MEMORANDUM FOR THE FILE

RE: 616 Simonton St/625 Angela St (permit application # 6459)

FROM: Karen DeMaria, Interim Urban Forestry Manager,
City of Key West

The following is a review of the plans to be reviewed and authorized by permit #6459:

July 1, 2013 Existing Tree Map

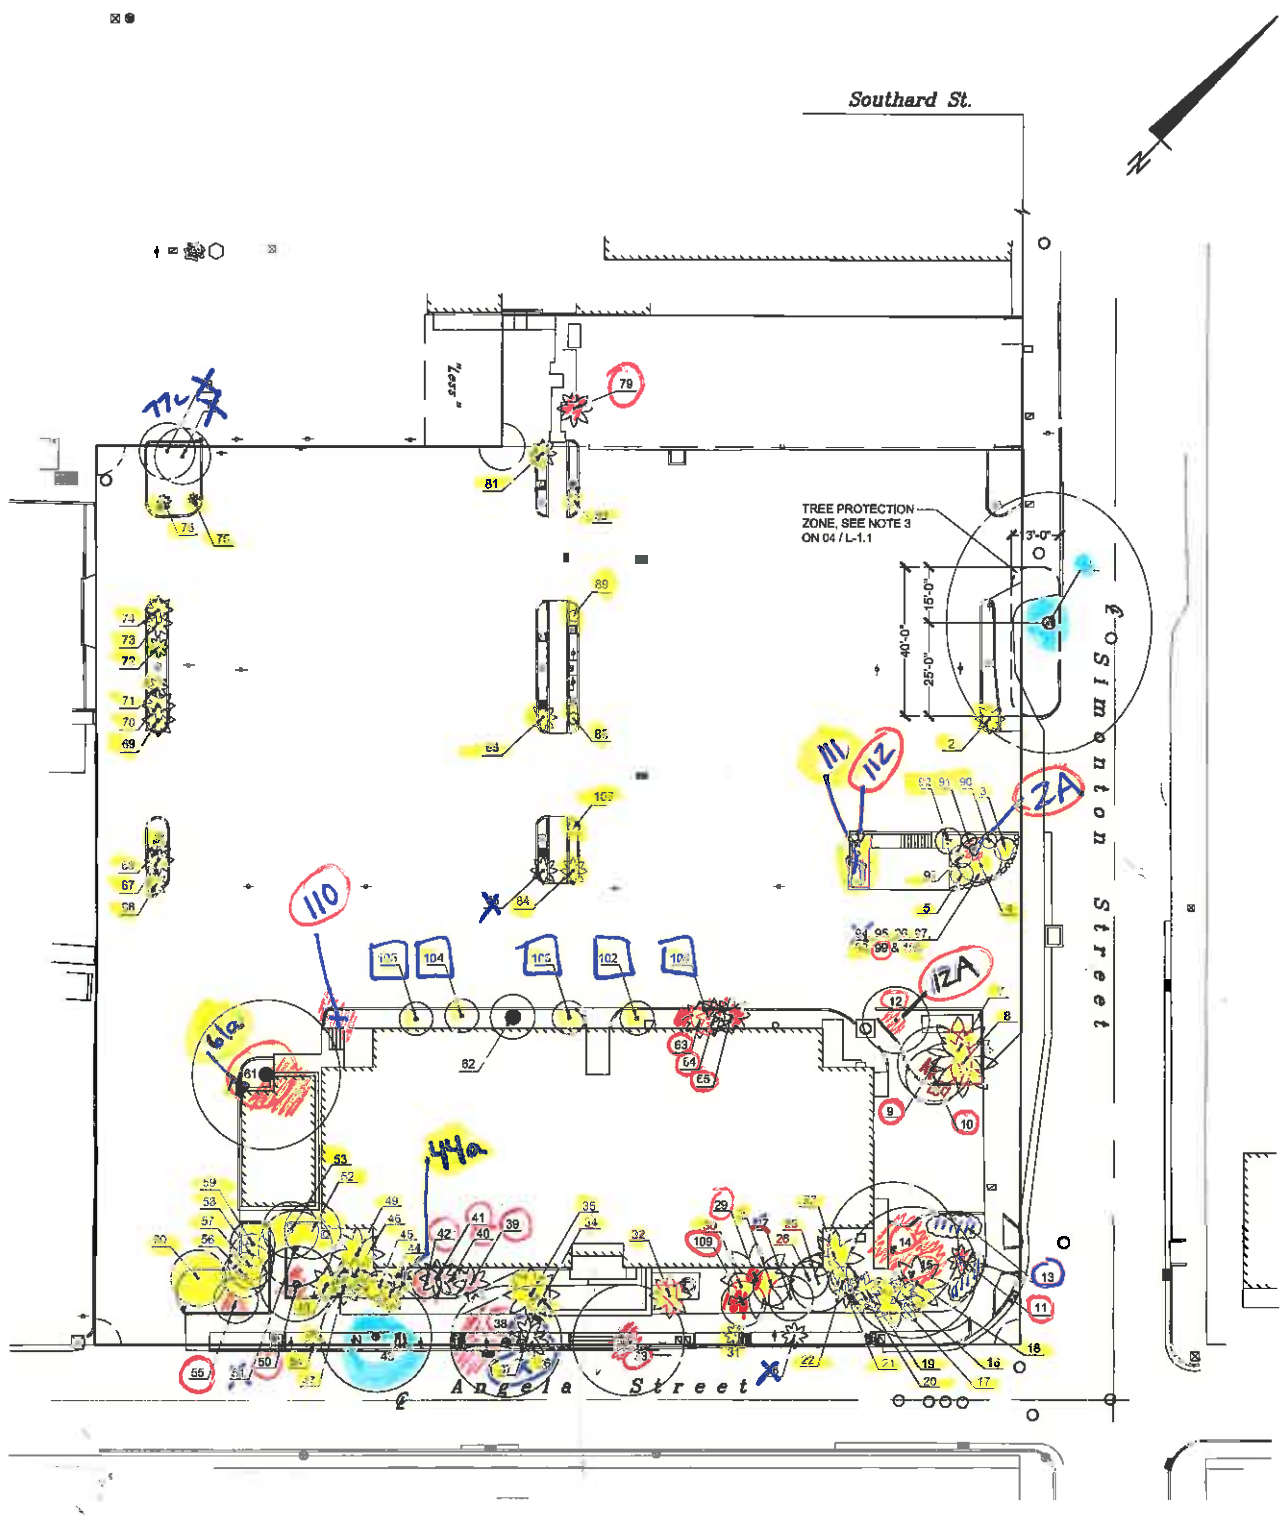
Crotons?

very large

Relocate?

save?

look at each one - rereview

Relocate?

not reg

relocate?

110 Ficus native - strangler

multibranch 42" dbh total remove

111 4 Jamaica Capers — relocate

112 4i tree (spanish lime) — remove

44a - Thatch palm (relocate)

61a Thatch palm (relocate)

62a Alexander palm (relocate)

63a Thatch palm (relocate)

64a mahogany (relocate)

65a mahogany (relocate)

77c 4i Pittcolobium (remove)

103a 2 Thatch palms relocate

Title:
EXISTING TREE DISPOSITION PLAN

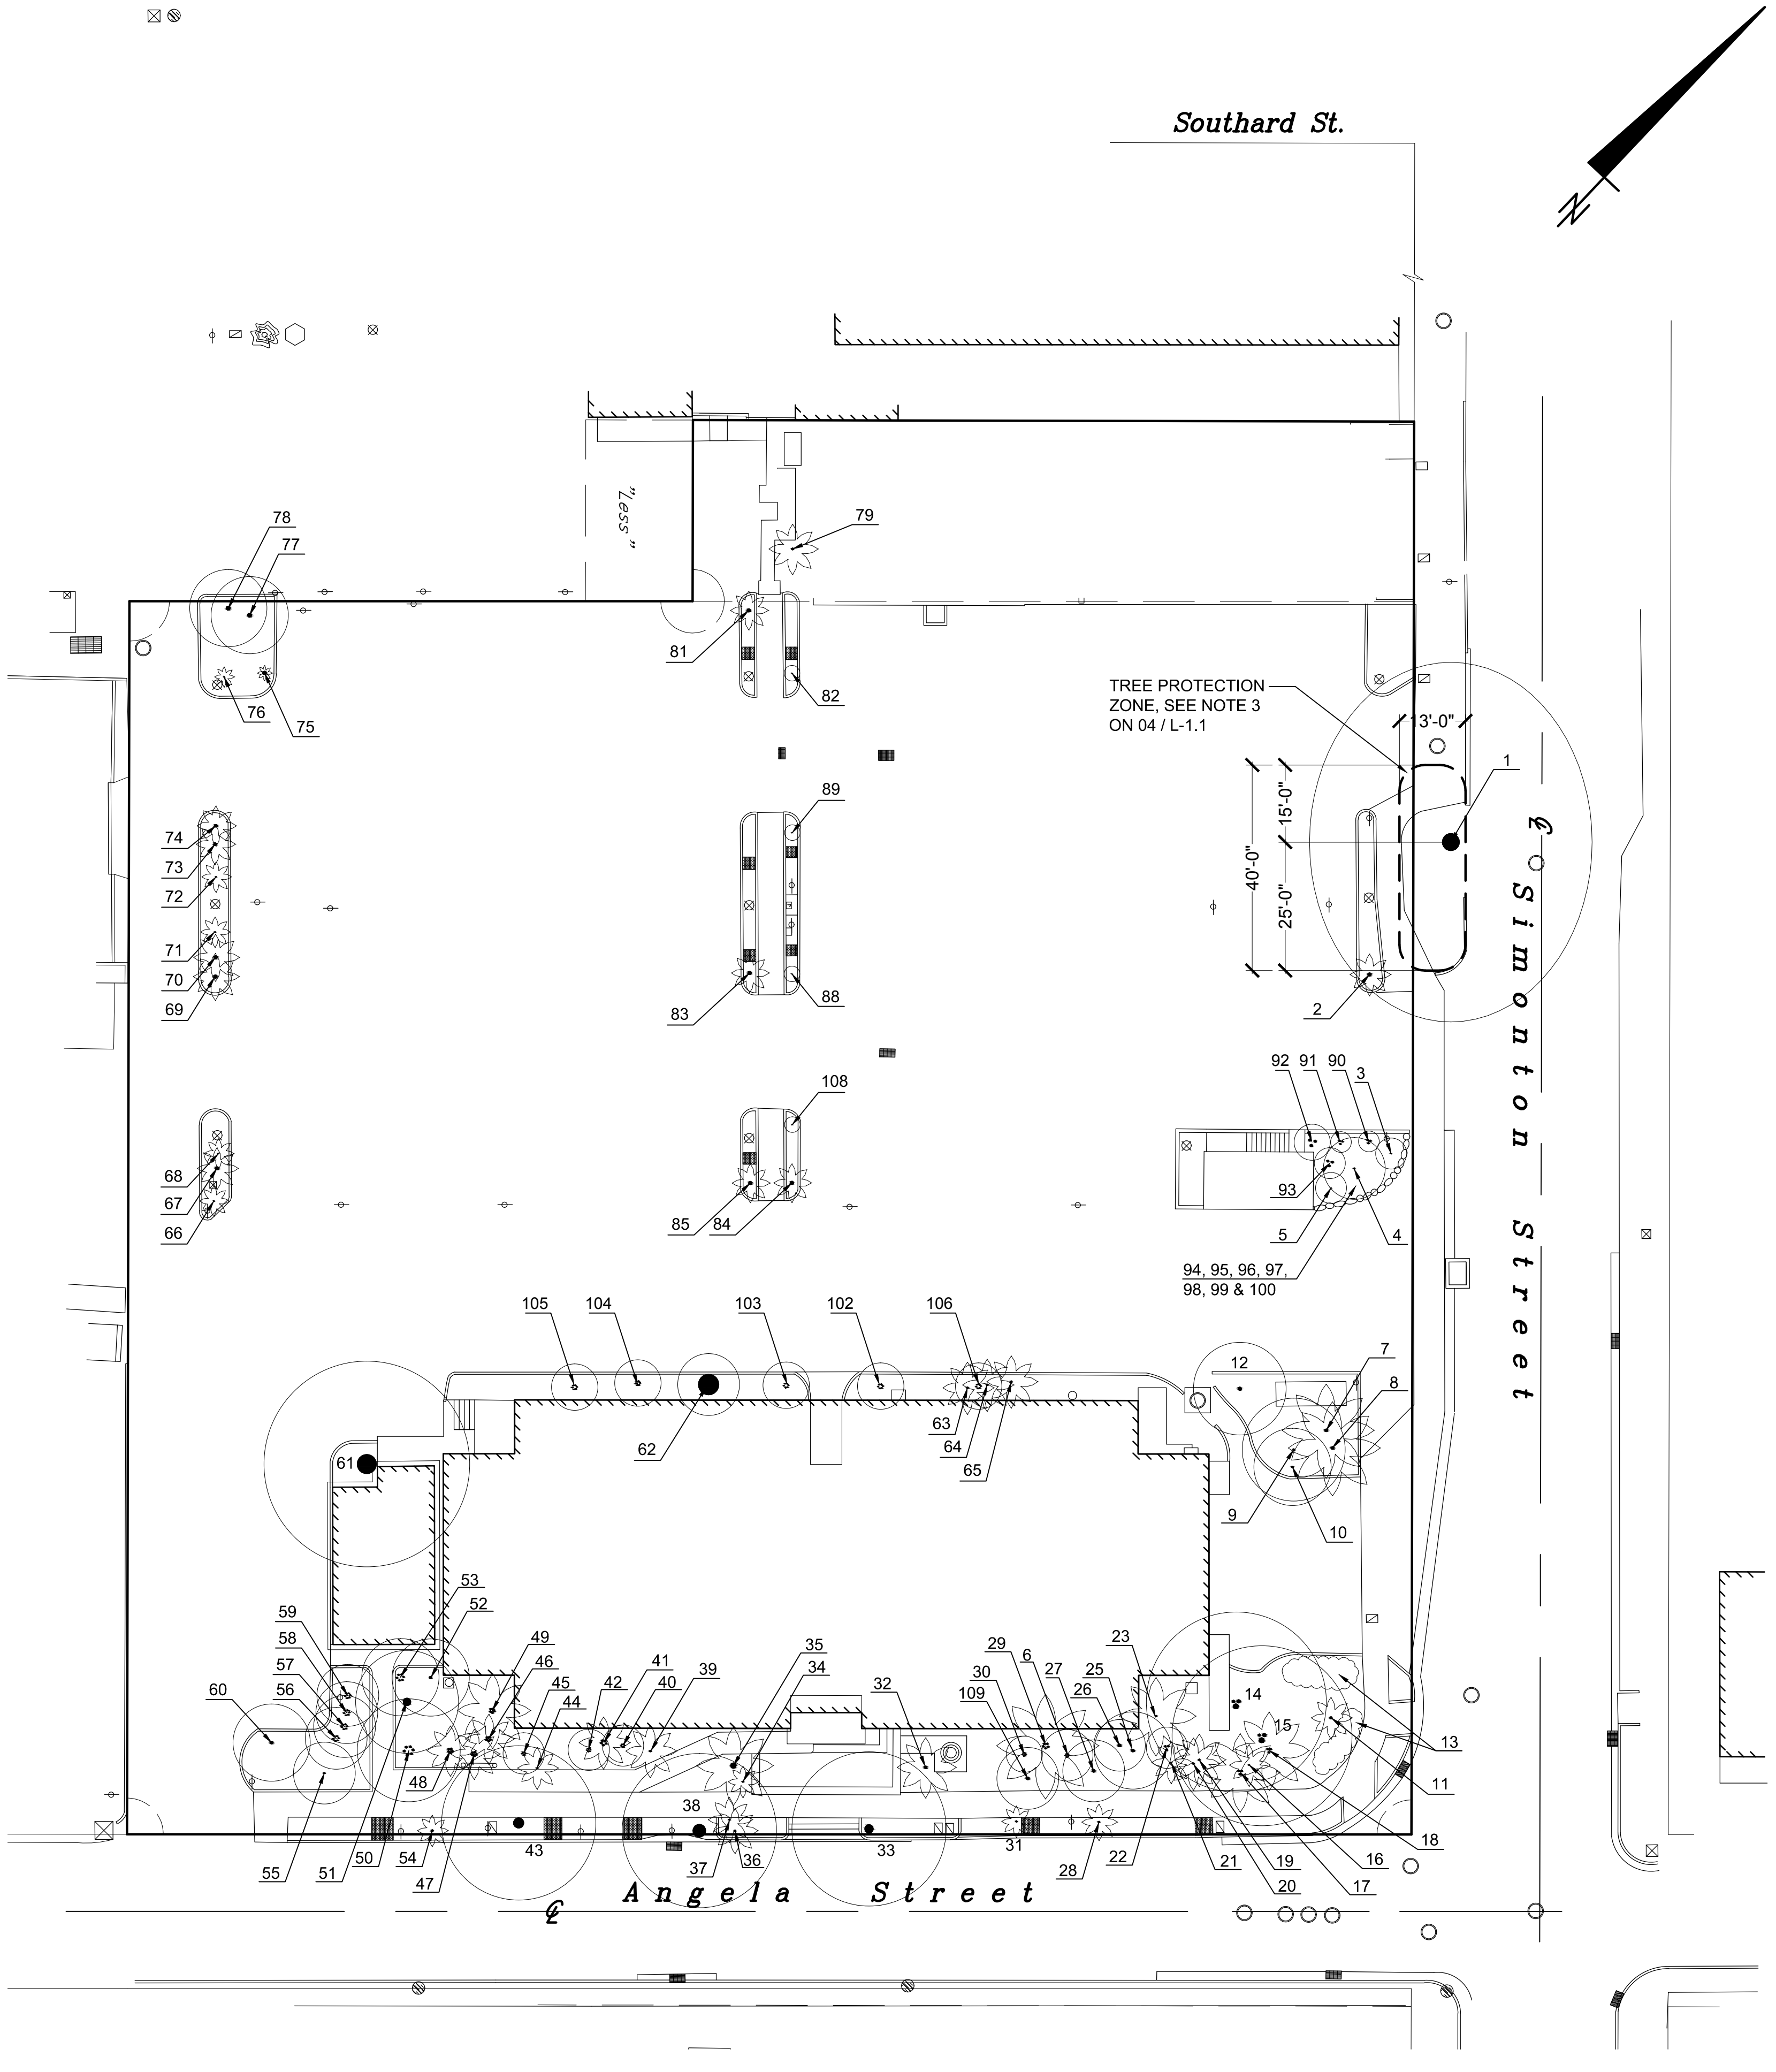
1. Trees to remain: The contractor will use proper tree protection measures around the mahogany tree on Simonton Street and around the Royal Poinciana tree on Angela Street during demolition and construction.

Area of trees to be removed in the parking lot rear area-northwest corner.

Royal Poinciana tree #38, to be removed.

Royal Poinciana tree #33 to be removed.

1. The City will require the contractor to use proper tree protection measures around the mahogany tree on Simonton Street and around the Royal Poinciana tree on Angela Street during demolition and construction.

2. The relocation of 81 plants from the site to include 43 palms, 29 dicot trees, and 9 crotons, as listed on the existing tree replacement list dated July 1, 2013. Trees will be relocated to City property. A map and plan will be created prior to the actual relocation of the plants. Trees will be monitored for one year. Any trees that do not survive after one year will be replaced with a similar tree.

3. The removal of (2) Strangler figs, (2) Draceana, (2) Autograph trees, (2) Royal Poincianas, (1) Yellow Poinciana, (1) Jasmine, (1) Spanish Lime, (1) Pithocellobium tree, and (1) Gumbo Limbo and (2) Christmas palms, (1) McArthur Palm, and (5) Alexander Palms. Total required replacements will be 8 native palms, 4ft tall and 174 caliper inches.
